# REGIONAL REVIEW NOTICE

ARC REVIEW CODE: R14052281

**Name of Proposal:** KD Towers

**Description:** The proposed KD Towers development is located in unincorporated Gwinnett County at 5064 Singleton Rd., Norcross, GA 30093. The development will include a 12-story, 530-unit senior housing facility and is adjacent to an existing private school.

ZONING SITE PLAN FOR:  
**K.D. TOWERS**  
**NEW SENIOR HOUSING CENTER**

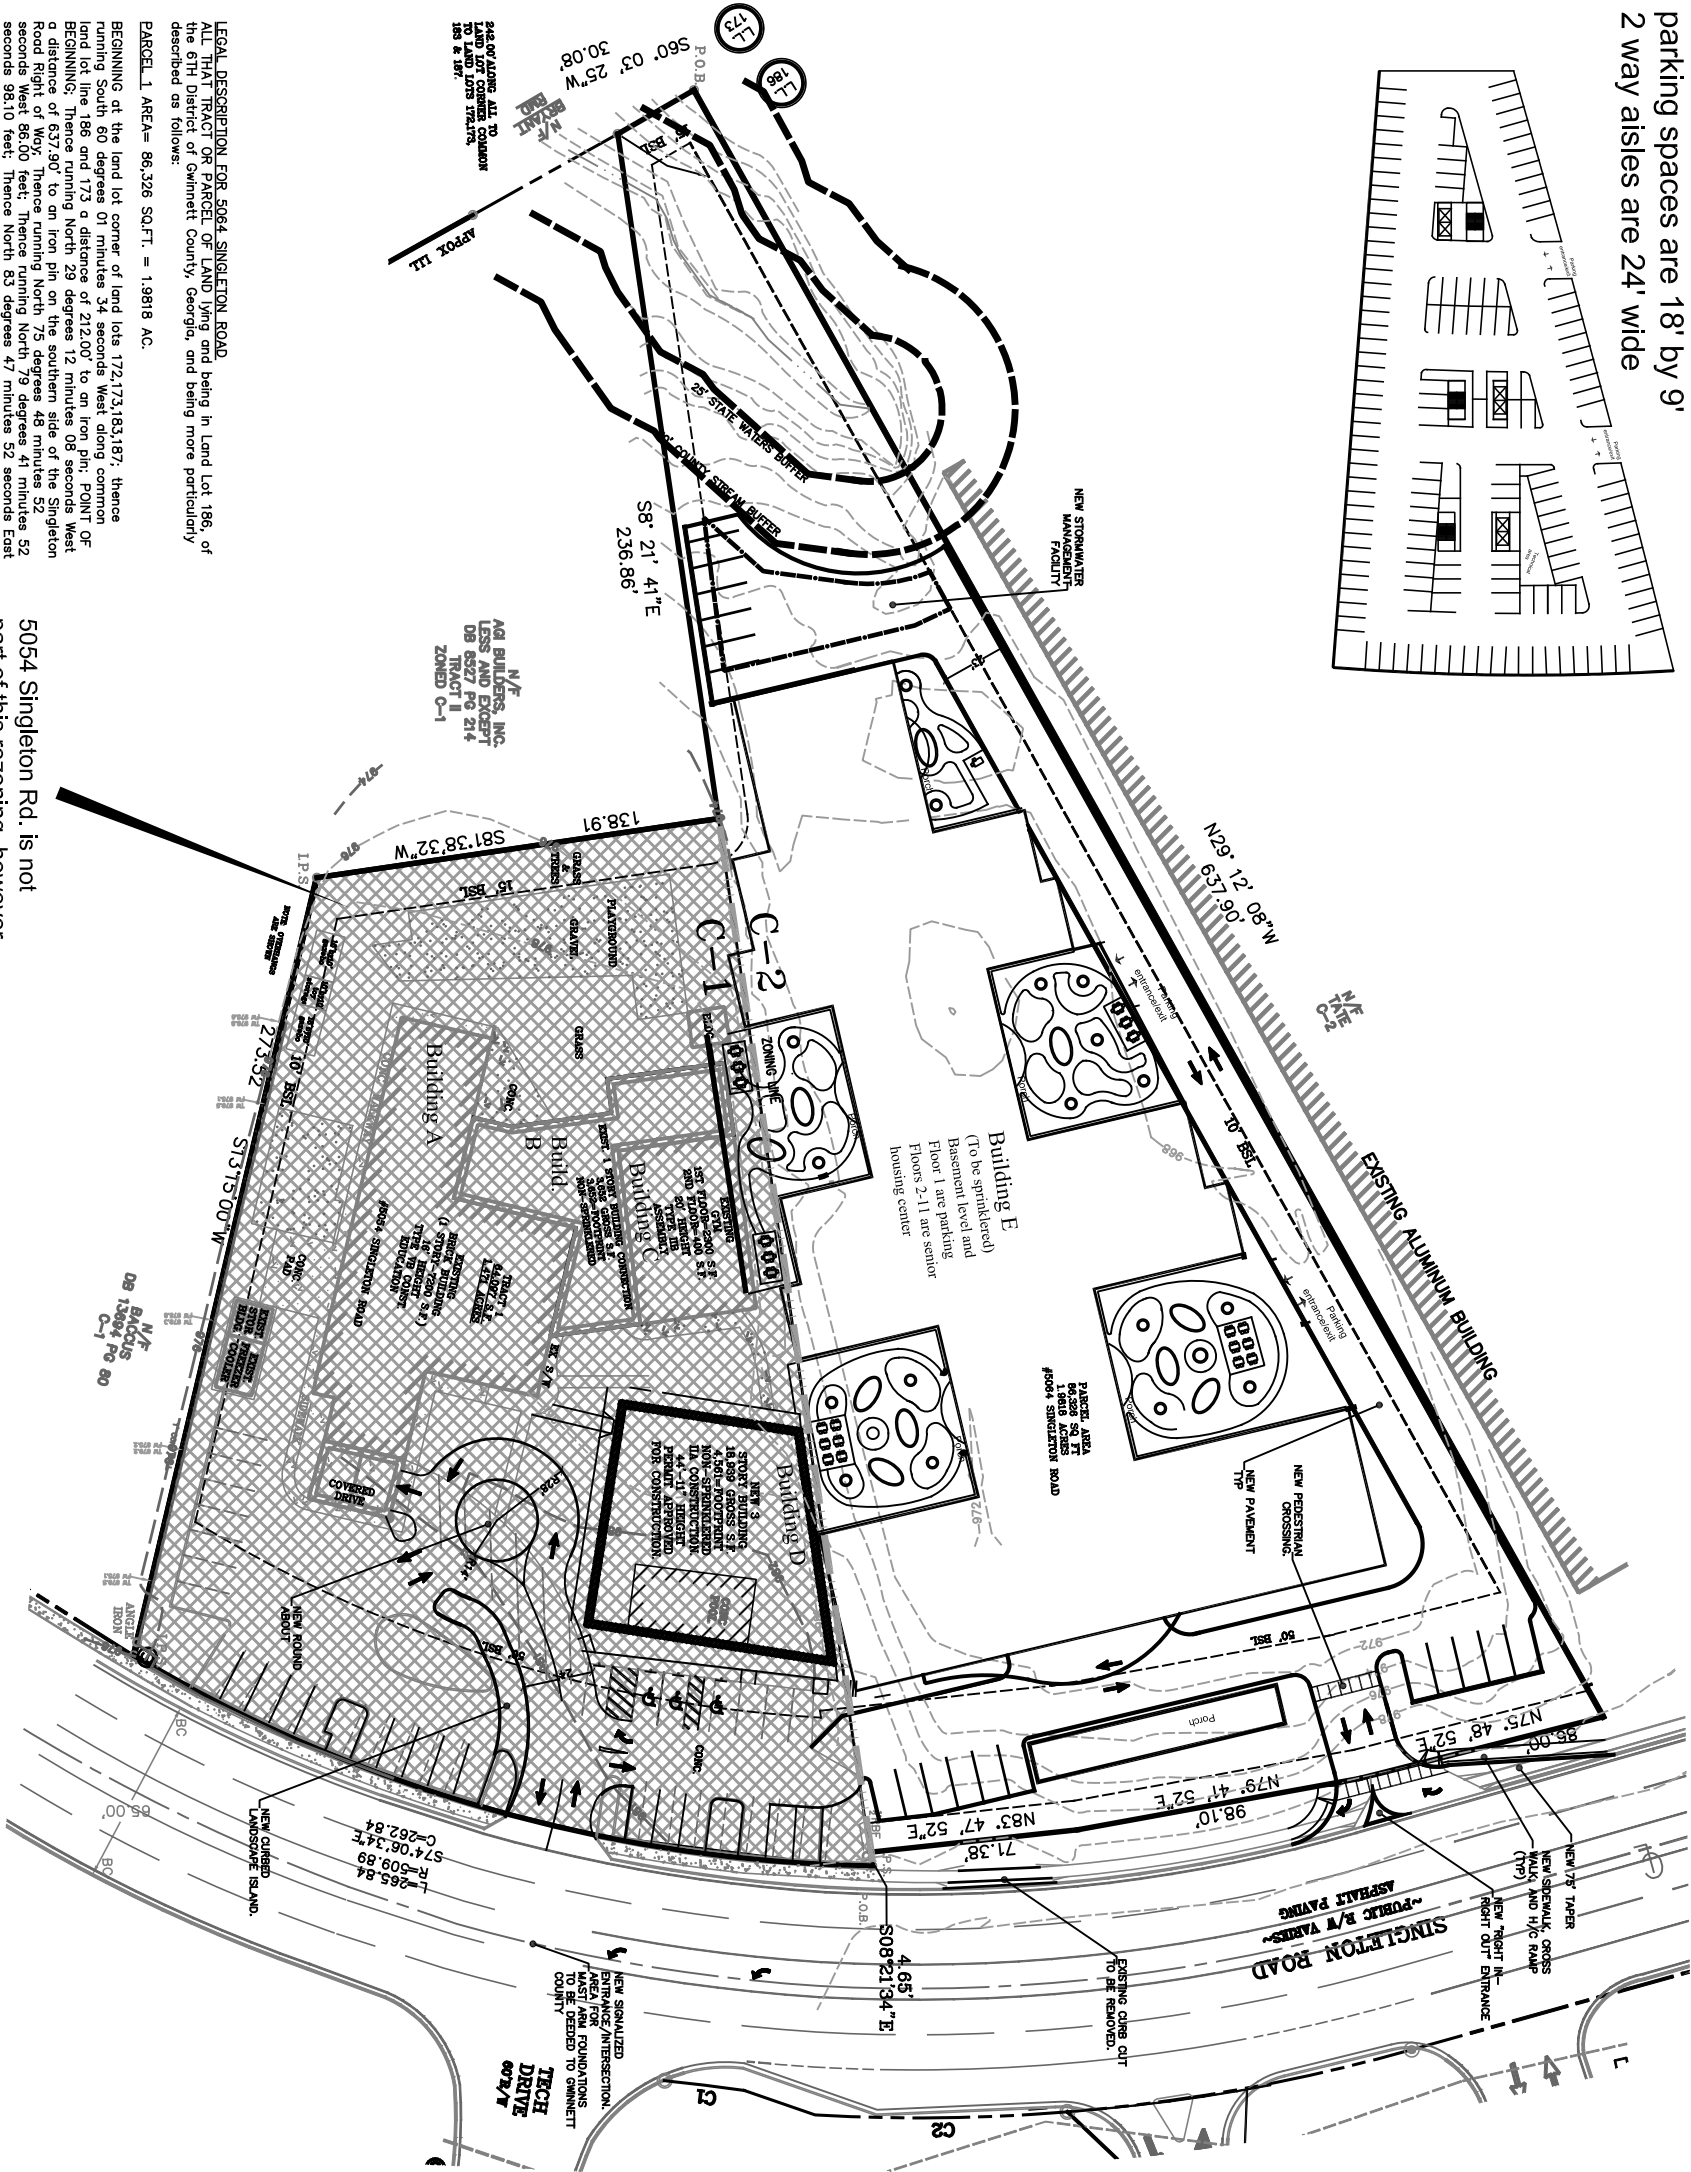
Site access is proposed to be directly across from Tech Drive at Singleton Road, located on an adjacent parcel. A drive will be constructed on the northern edge to link the two parcels. The developer is working with Gwinnett County to signalize the intersection of Tech Drive and Singleton Road. An additional entrance is provided via a right-in, right-out on the north-west portion of the subject site.

The property is in the Yellow River watershed, which is not a water supply watershed portion in the Atlanta Region or the Metropolitan North Georgia Water Planning District. The USGS coverage for the project area does not show any streams in the project vicinity. However, the submitted plans show a stream at the southern end of the property. The 25-foot State Sediment and Erosion Control Buffer is shown, as is the undisturbed 50-foot County Stream Buffer. However, the additional 25-foot impervious setback/limited disturbance required under the County Stream Buffer Ordinance is not shown and is the site of a Stormwater detention facility and parking. If this stream is actually covered by the County Ordinance, a variance will be required to put impervious surfaces in the 25-foot additional impervious setback. Any other state waters that may be on the property will be subject to the State 25-foot Erosion and Sedimentation Act buffers. Any work within these buffers would require a variance.
